## REMARKS

HP-100203160

**FIG. 4A**

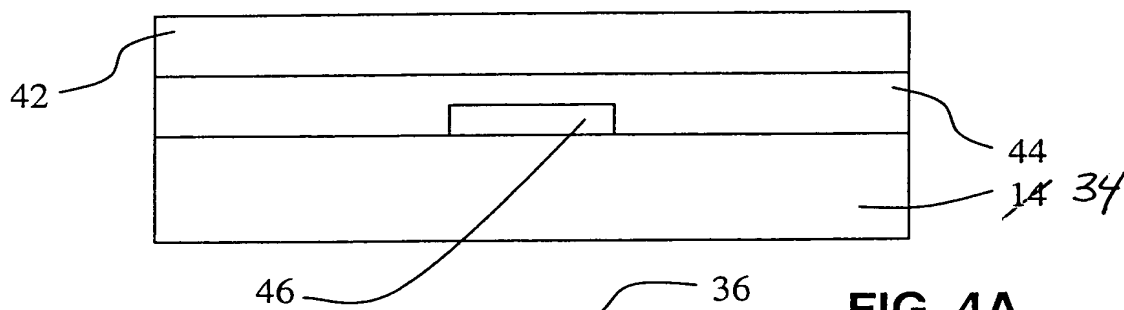
There are objections to the drawings. The examiner did not find a description of item 48 in FIG. 4C. The examiner's attention is direct to the paragraph beginning at the bottom of page 8 which identifies item 48 as the solution processed thin film transistor. Regarding FIG. 4A, a proposed drawing correction is submitted to change "14" to "34" as correctly observed by the examiner. The examiner did not find a description of item 40 as shown in FIG. 5B. The examiner's attention is directed to repeated references in the specification the "transistor channel 40", including in the paragraph discussing FIGs. 5A – 5C on page 9, e.g. at line 30. A proposed amendment to FIG. 5B changes numbers 10 and 12 to 30 and 32, consistent with the specification and FIG. 5C. This addresses the objection to FIG. 5B. Substitute formal drawings including the proposed changes are also submitted herewith, and acceptance is requested upon approval of the proposed changes.

**FIG. 7**

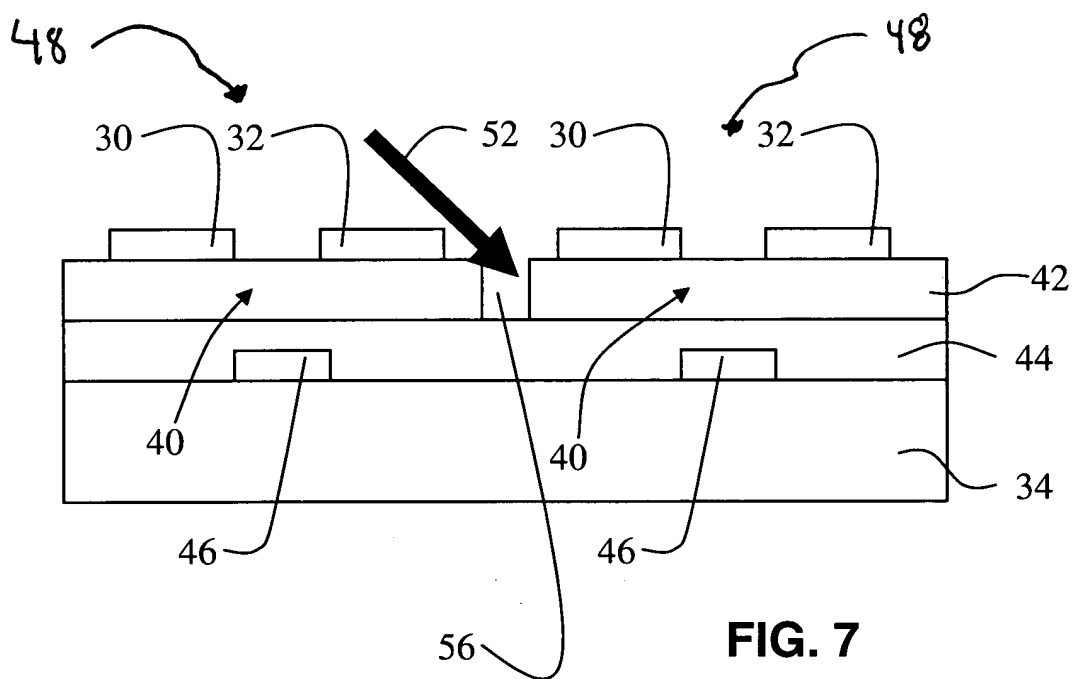
The examiner objects to the specification. At page 4, line 4, the examiner indicates that "-200" should be changed. It is believed that the symbol appearing at that point has been misread, it is not a negative symbol, but the symbol indicating approximation, and thus the "~200" recitation is correct. The "transistor device 8" on page 10 was incorrect, and has been amended to the "transistor device 29", consistent with the specification and FIGs. 3A-3C and FIGs. 6A and 6B. The "transistor device 48" of FIG. 7 on page 10, is correct in the specification, but the proposed drawing changes include a change to add an appropriate reference numeral to FIG. 7. The examiner's assistance in discovering these informalities is acknowledged and appreciated.
